Old Sauk Road Apartments Stormwater Management Report Cover Letter

STORMWATER MANAGEMENT REPORT & EROSION CONTROL PLAN

Revised: May 24, 2024

INFILTRATION BASIN

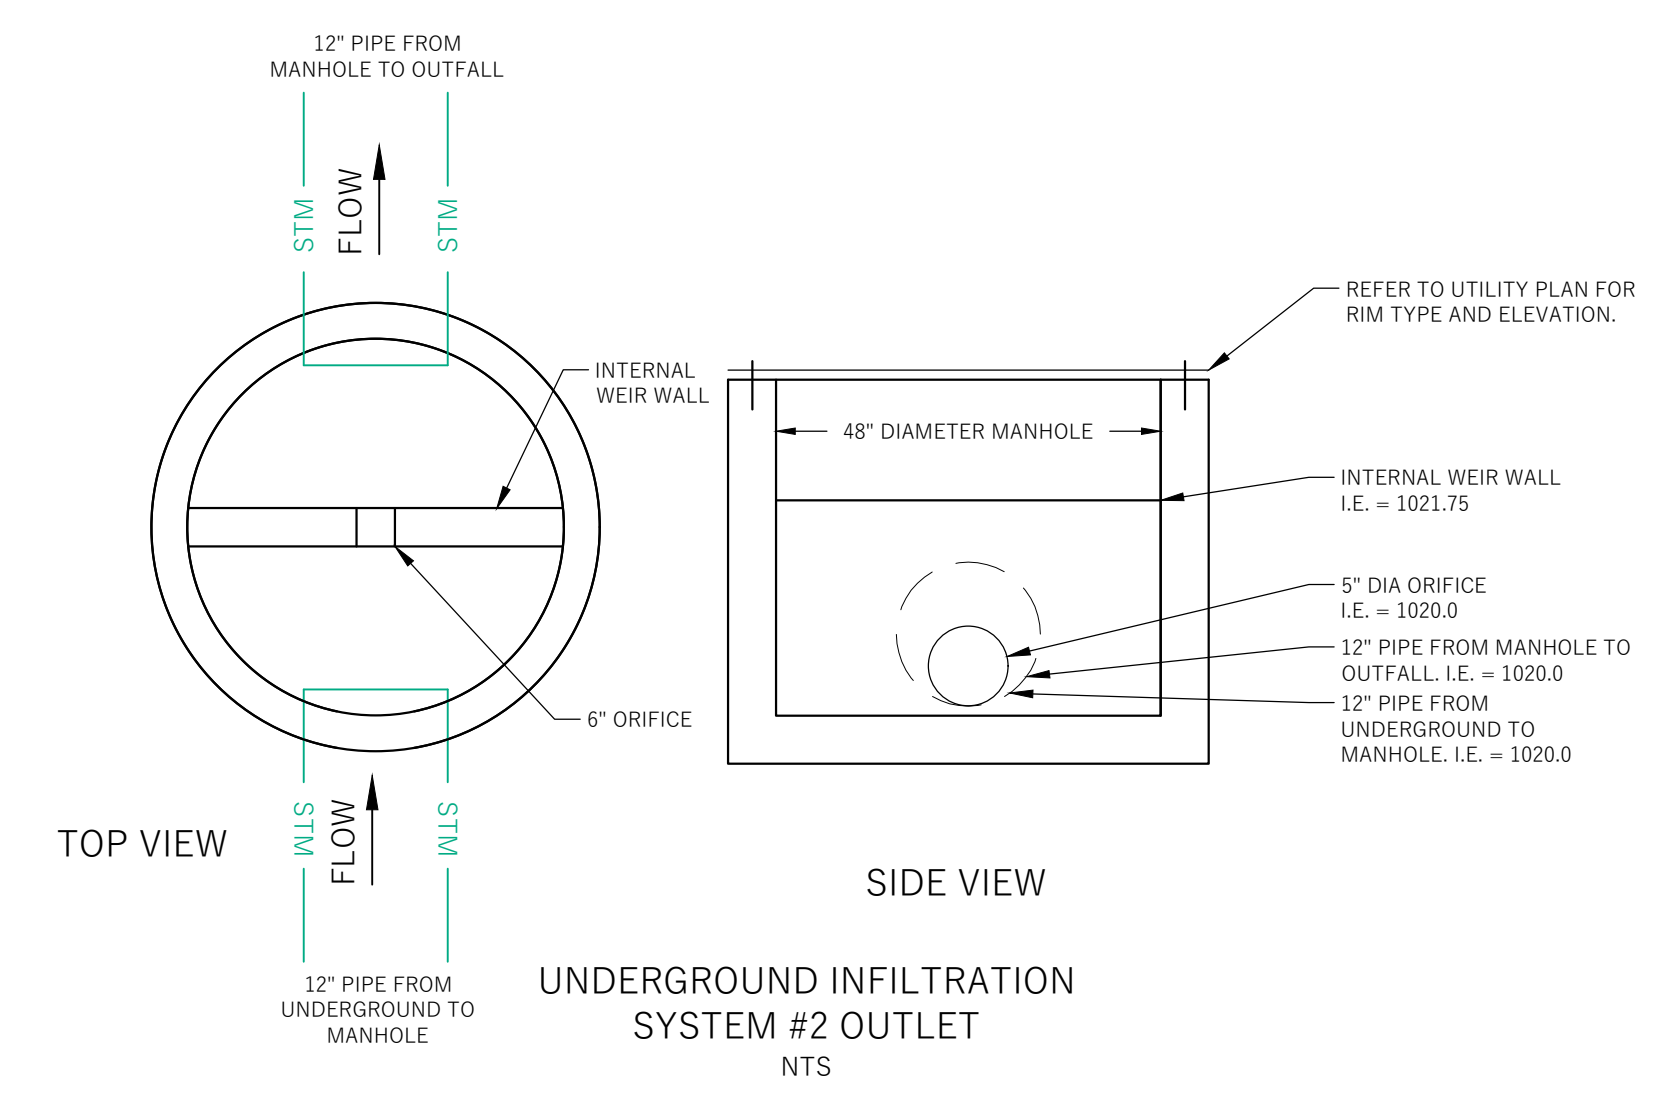
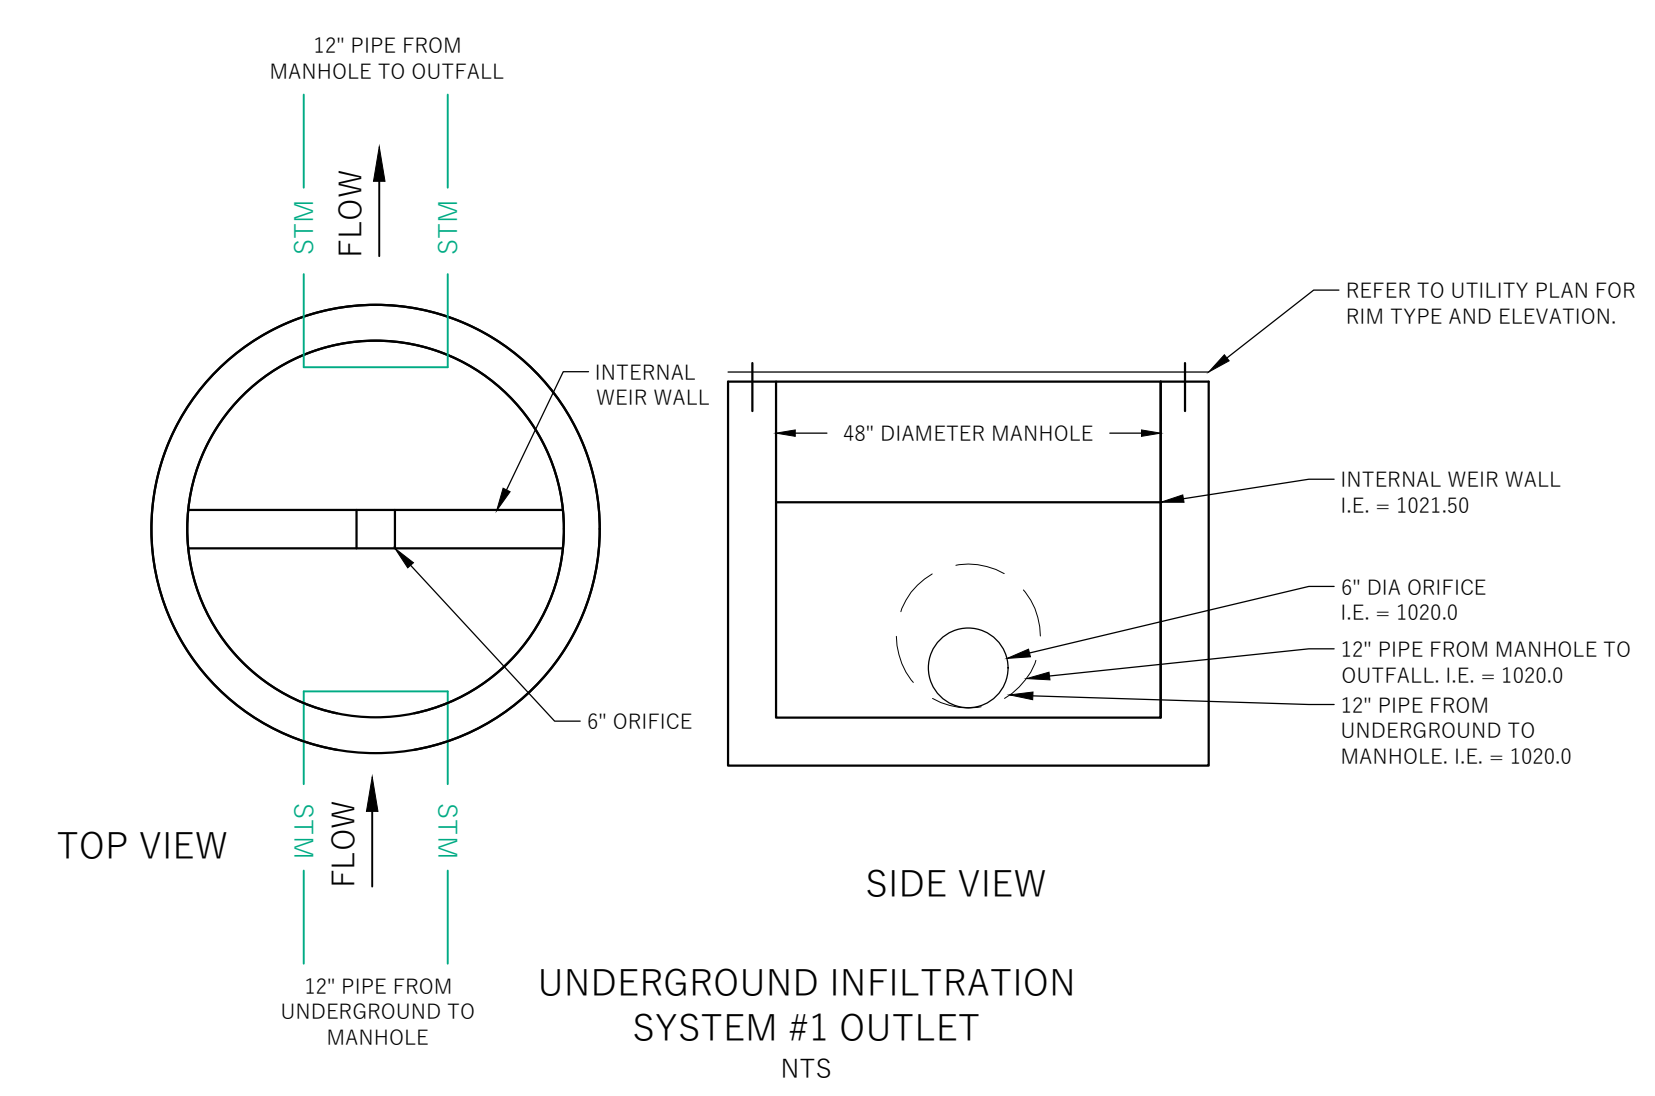
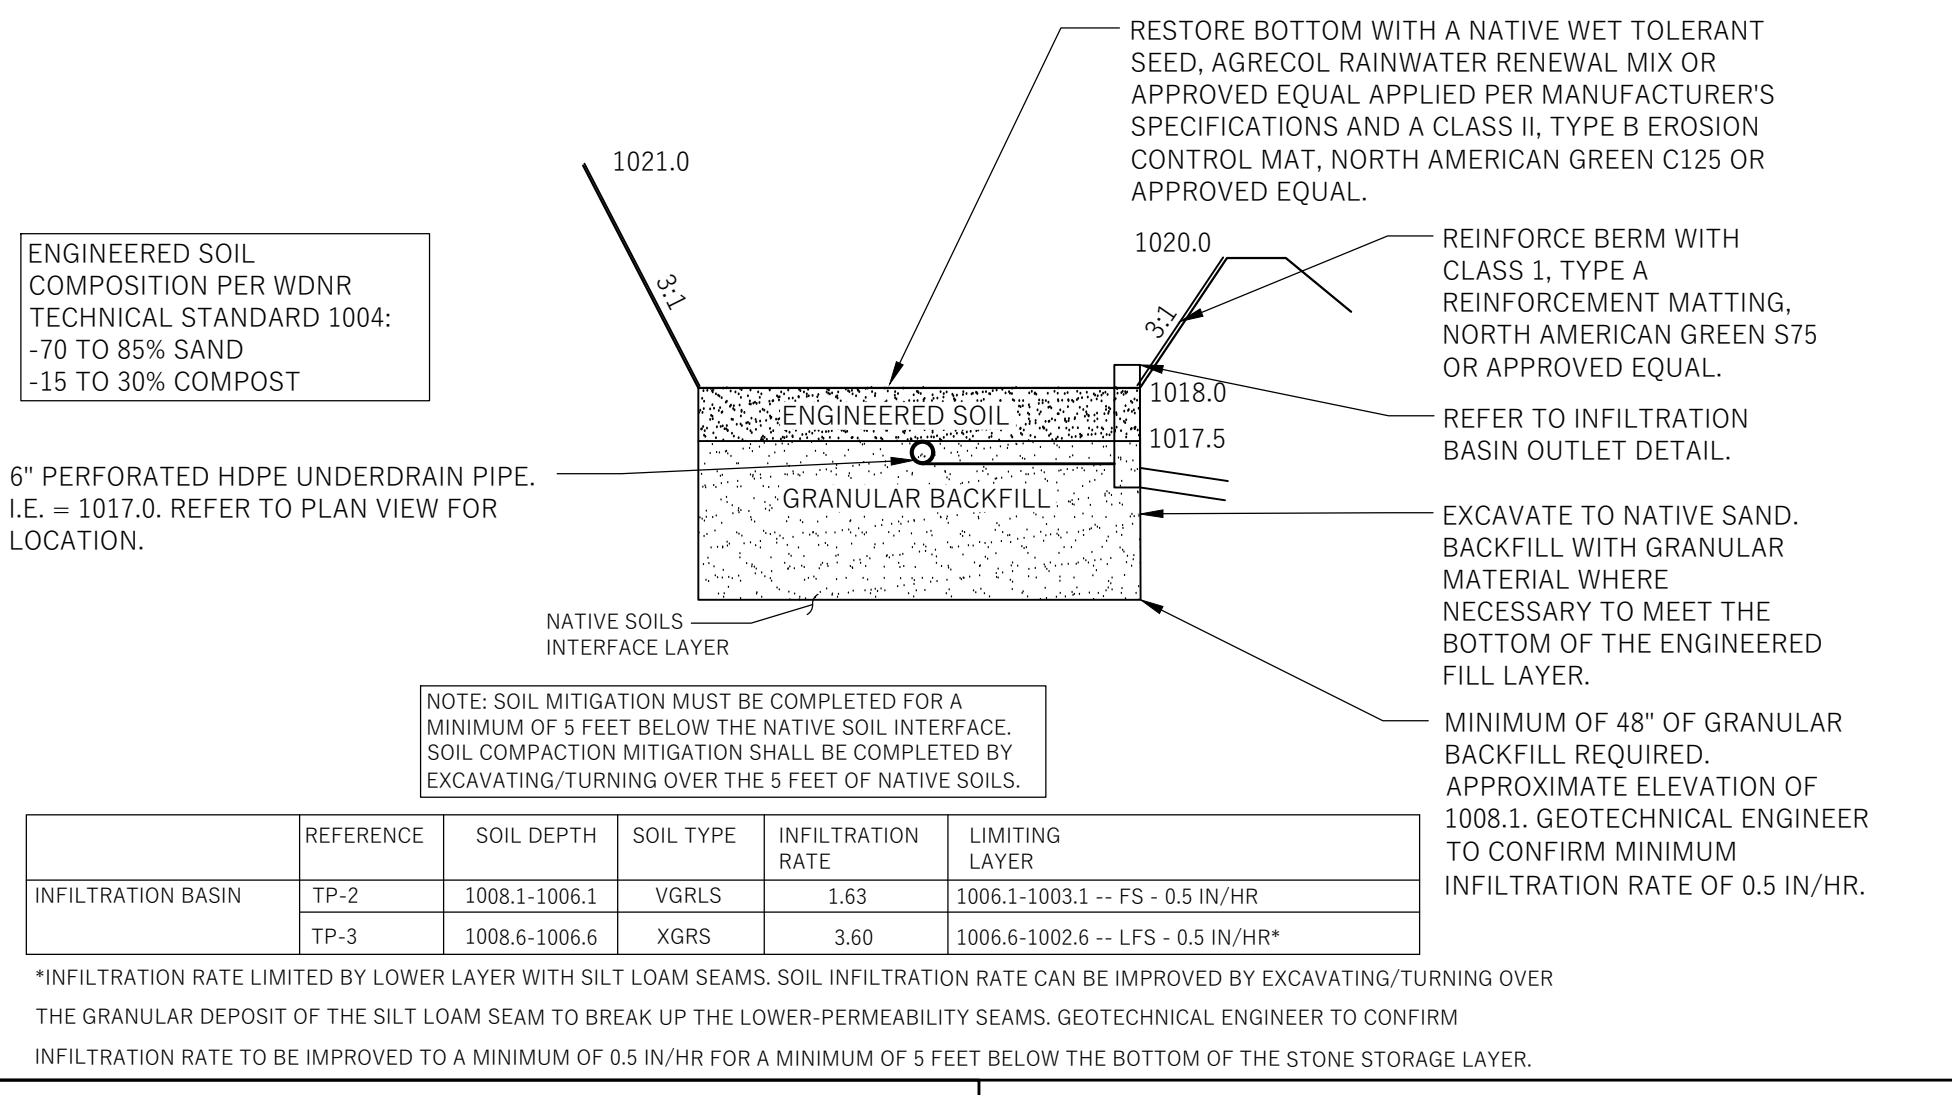
- a. The overflow weir for the infiltration basin is to the west per the note. The grading has been updated to more clearly show the location. The overflow to the south is to allow runoff overtopping Old Sauk Road to access the infiltration basin.

- c. All of the infiltration facilities will have the soils 5 feet below the native soil interface elevation excavated and turned to improve infiltration rates and mitigate soil compaction. Per the CGC note, the areas with silt loam seams that have an infiltration rate of 0.13-0.5 in/hr can have the infiltration rate improved to 0.5 in/hr by excavation/turning of the silt loam seams. Additional notes have been added to the stormwater report and plans to clearly note the soil compaction and silt loam seam mitigation.
